## **Field Safety Notice**

### **Affected Products: Shimadzu CVS system : Trinias**

Figure 1

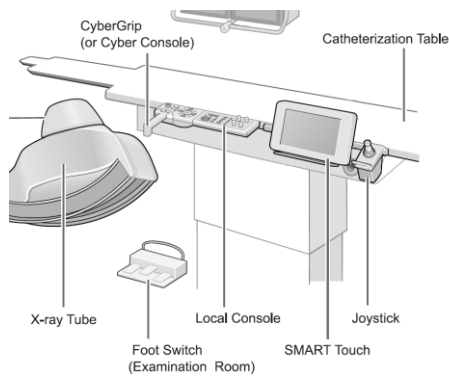
If SMART Touch is installed as shown in Figure 1, press the "X-Ray OFF" button shown in Figure 2 to stop X-ray output.

If the problem occurs while using the wireless FOOT Switch, take the following actions.

If SMART Touch is not installed, turn off the system and stop X-ray output.

In addition, stop using the wireless foot switch and contact your service representative.
